Subject: Minor Amendment for Dorado Country Club Planned Area
Development – Modify Collection Vehicle Backing Distance

SUBJECT: DORADO COUNTRY CLUB PAD-24
MINOR AMENDMENT – REQUEST TO EXCEED COLLECTION VEHICLE
BACKING DISTANCE
JN 3994-C

From: Ken Perry <kperry@perryengineering.net>
Sent: Monday, June 27, 2016 9:15 AM
To: Daniel Castro
Cc: Anthony Boone; patricia.gehlen@tucsonaz.gov; Tri Miller; Tom Ryan ; Alexandra Hines
Subject: RE: 3994-C - Dorado Golf Course - DP16-0047

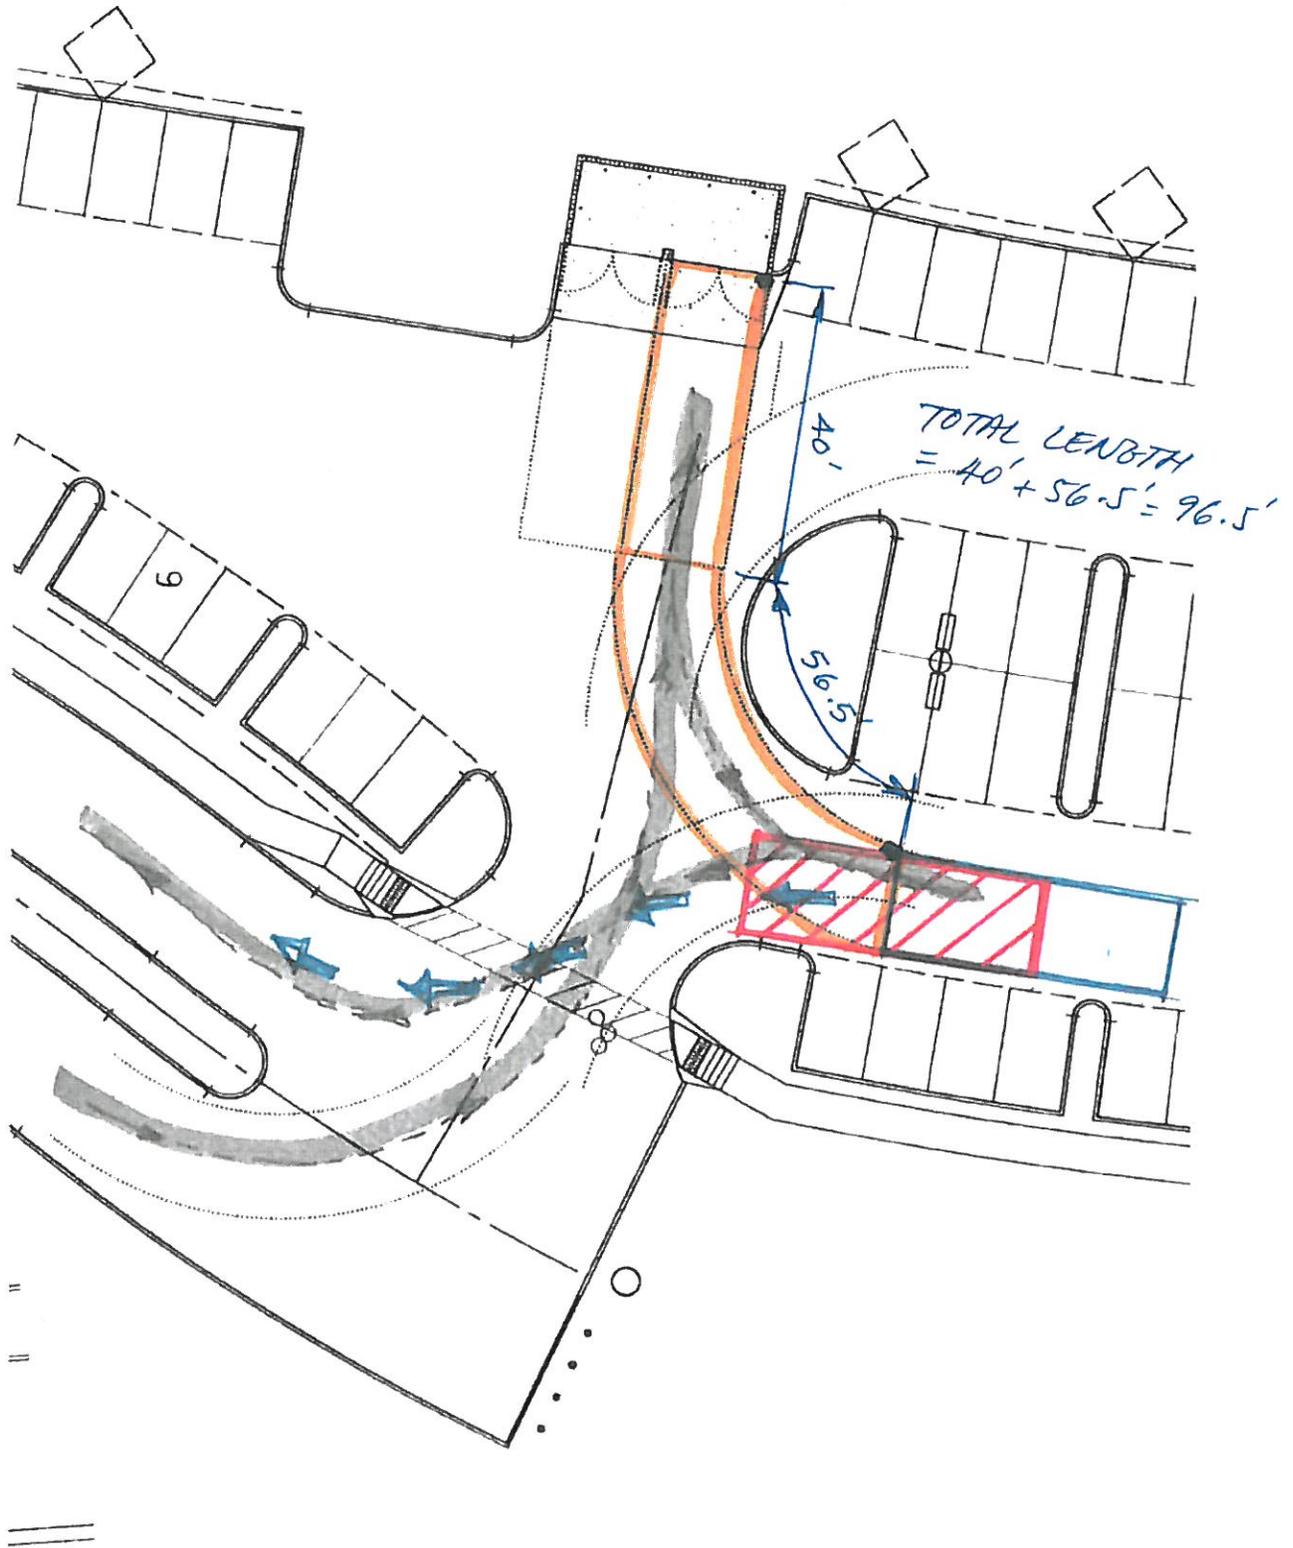
Please see the attachment. By the turning radii provided on your plan the service truck will need to back to the blue outlined position. It will then need to pull forward into the red outlined position before exiting in the blue arrow path. Add the turning radii to the Development Plan that demonstrate the truck can make the exit maneuver within the confines of the curbs.

Should the truck be able to make the exiting turns, because the backing maneuver exceeds the allowable backing distance of 80 ft. by some 50 ft., you will need to submit a TSMR request for relief from TSM 8-01.5.3.F. Your other responses for comments 2 and 3 are acceptable.

Comment 1. The new location of the enclosure requires the collection truck to travel the loop road and make the turn at the clubhouse. The turning templates provided on the plan show the truck cannot make this turn. Provide a location for

the enclosure where the collection truck can service the containers while meeting the maneuvering requirements in TSM 8-01.5.3.E. , and without exceeding the 80 ft. maximum backing distance as specified in TSM 8-01.5.3.F. Show the path of the collection vehicle as it leaves the loop road and turns back onto Club Drive to exit.

Thank you for getting back to us that quick. There is one comment I would like to make to your response. Based on the attached PDF, I figured the backing distance for the truck is only 96.5' (56.5' + 40') assuming the truck is 40' long. However, with the arm folded up, the truck is actually only 35' long, which yields a backing distance of about 92'.

Response: *The turning radii shown on the plan, in front of the clubhouse, are for fire truck and other vehicle. The trash collection vehicle should be able to pull straight into the trash enclosure and back out using the easterly PAAL, as highlighted in the attached exhibit. The trash truck does not need to travel north, near the front of the clubhouse.*

PAD 24

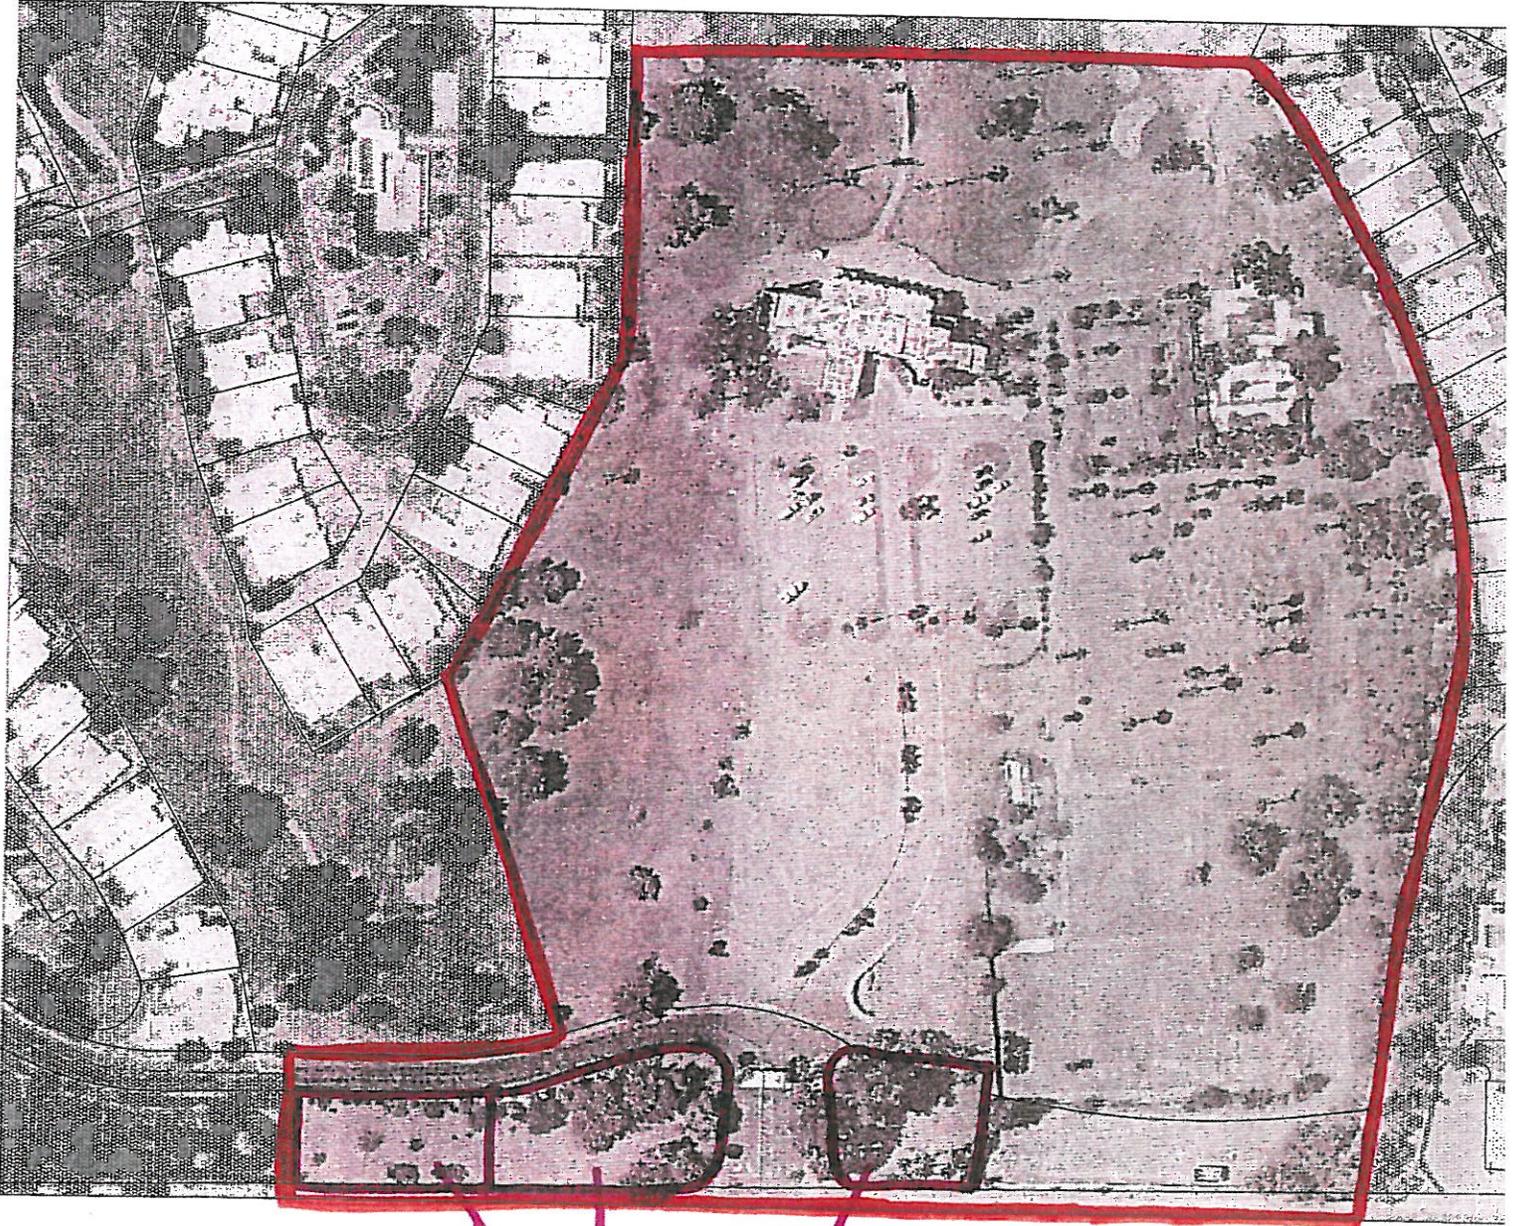
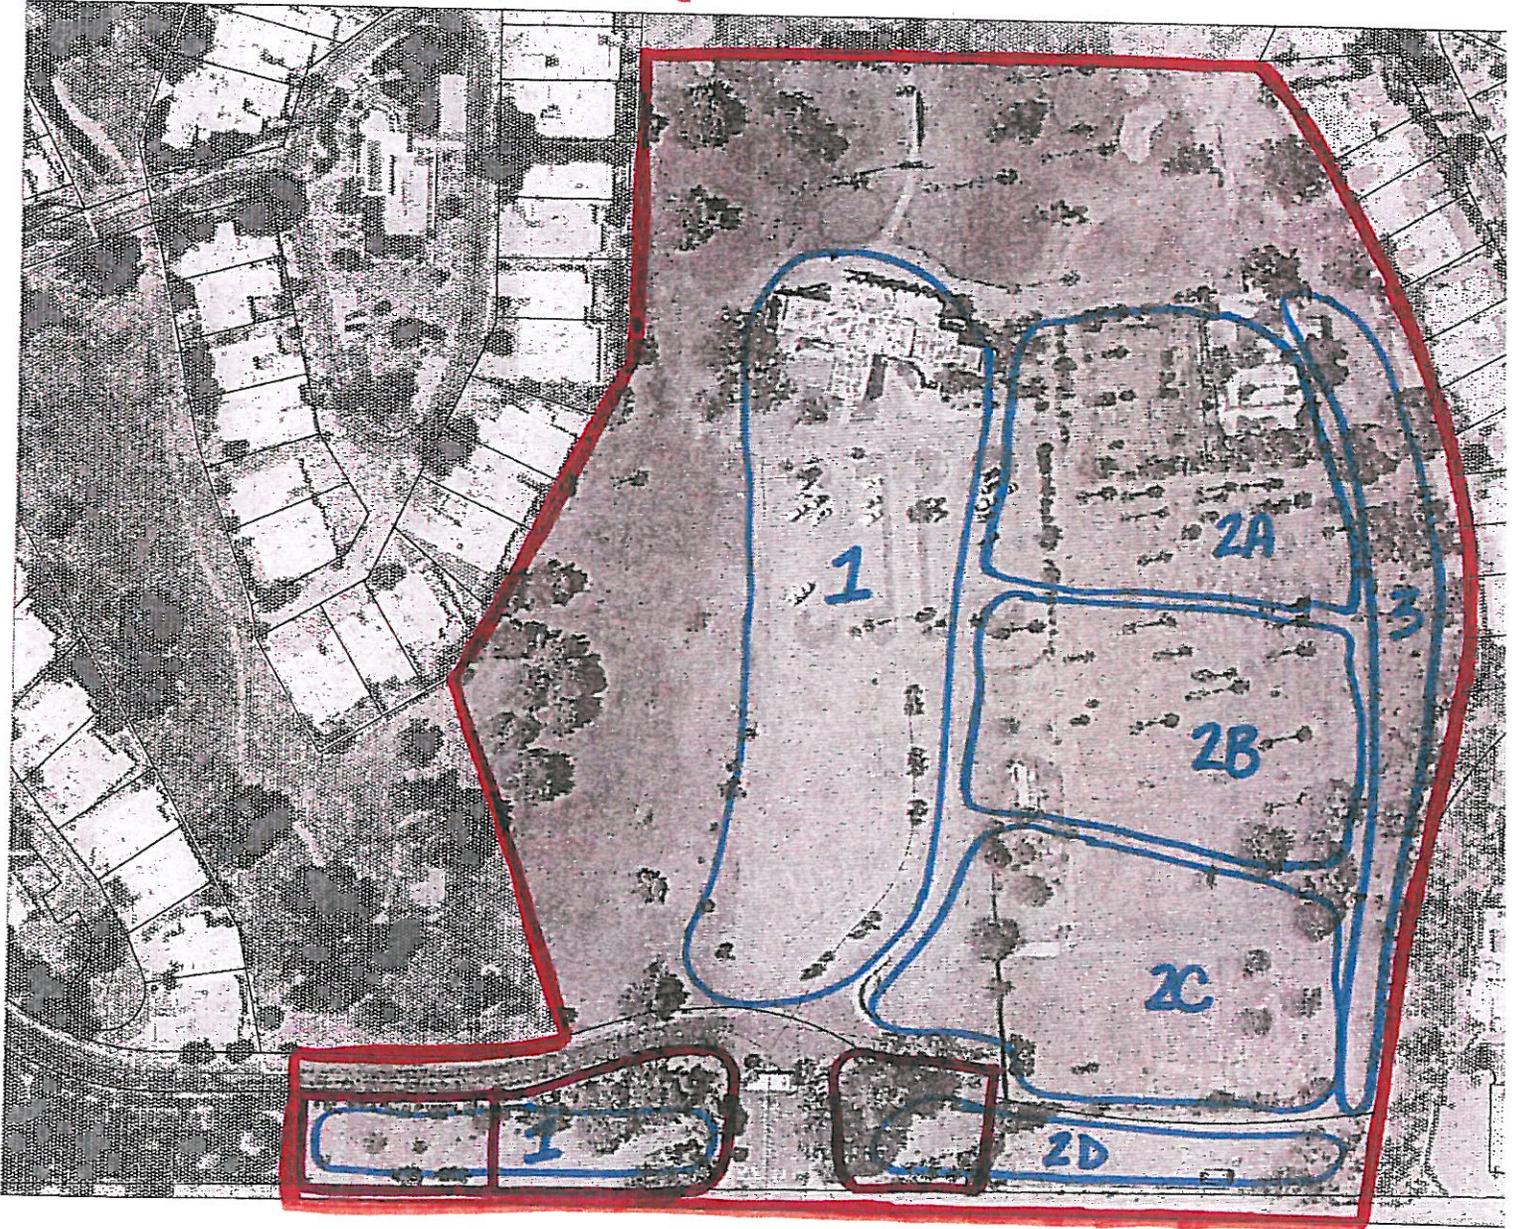
The Dorado Country Club Estates Master Homeowners Association owns three parcels along the Speedway frontage. HSL and the Dorado HOA plan to have a construction easement to allow HSL to build the sidewalk connection to Speedway and install additional landscaping on the HOA's west side parcels (see attached Exhibit A).

Modifications to the golf course are no longer required. Under the proposed site plan, development no longer encroaches into the golf course area. Additionally, the proposed site plan includes a revised phasing plan for the PAD (see attached Exhibit B). As noted above, our revised proposal includes certain requirements to be constructed in later phases of the project.
